# CITY OF PETALUMA

## ADDENDUM NO. 4

### Ellis Creek Water Recycling Facility Tertiary Filtration Expansion UV Disinfection Equipment Modifications Project City Project Number C66401416

November 17, 2022

JOB NO.  
7310L.10  
DRAWING NO.  
**08E01B**  
SHEET NO.  
43 OF 56

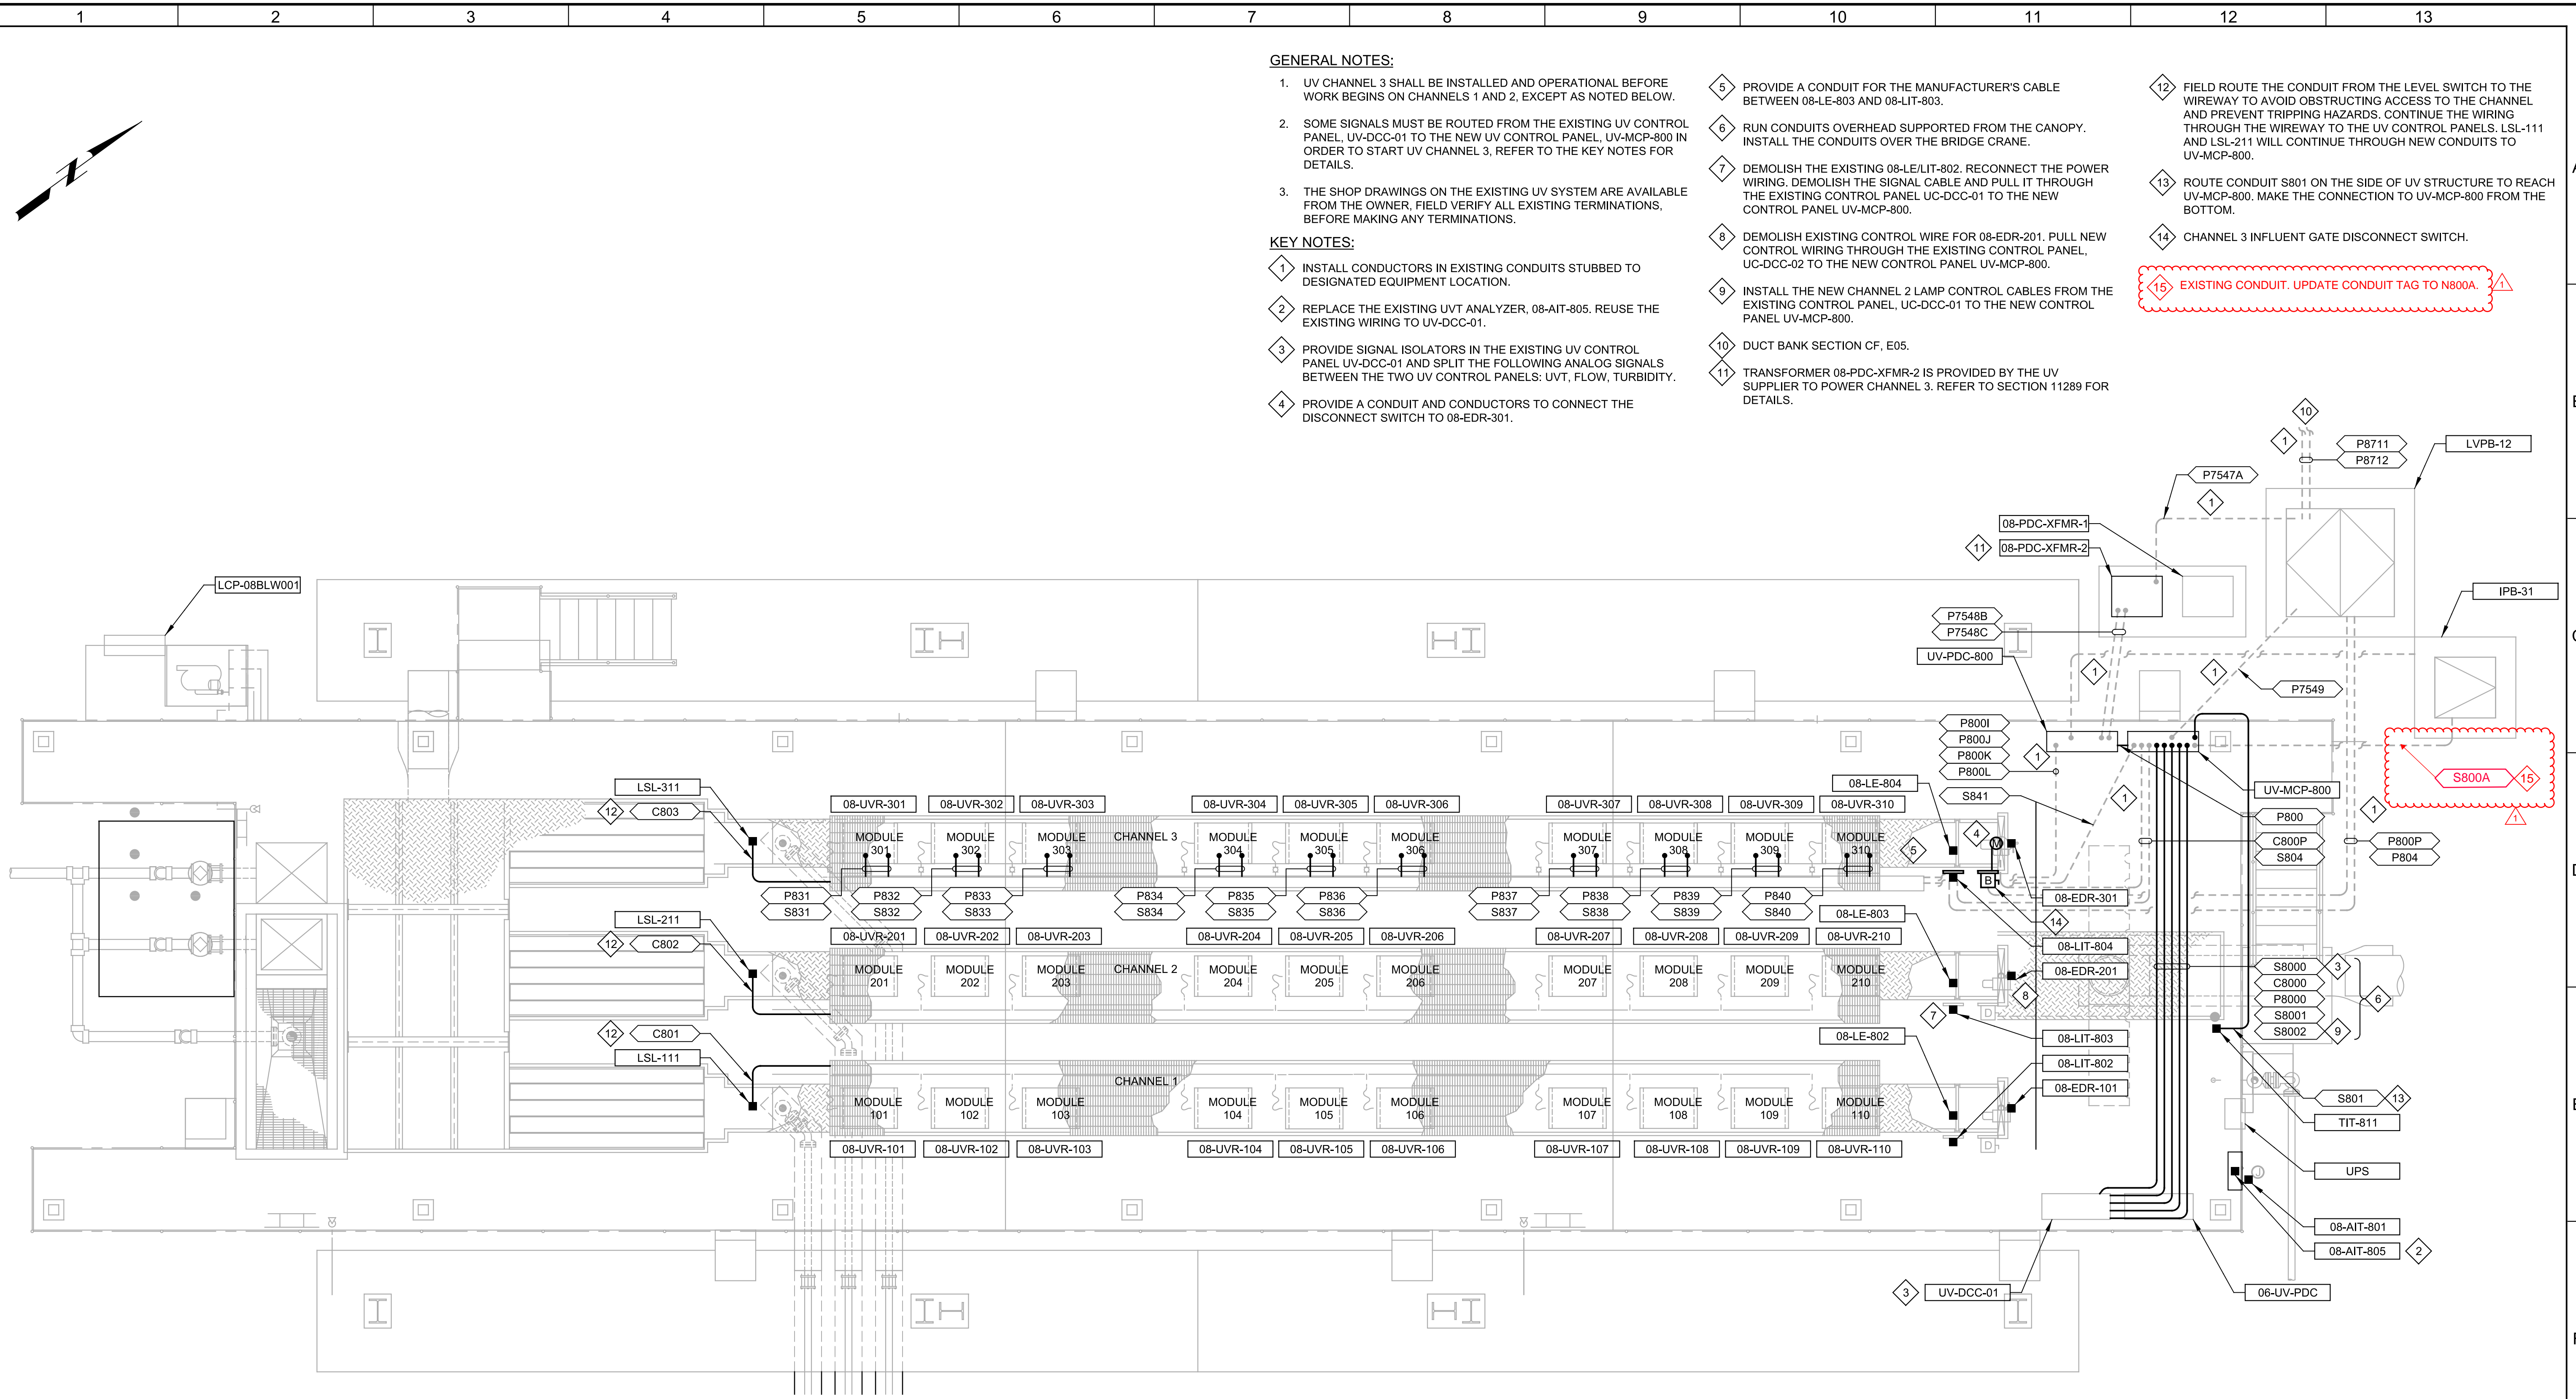
15 EXISTING CONDUIT. UPDATE CONDUIT TAG TO N800A.
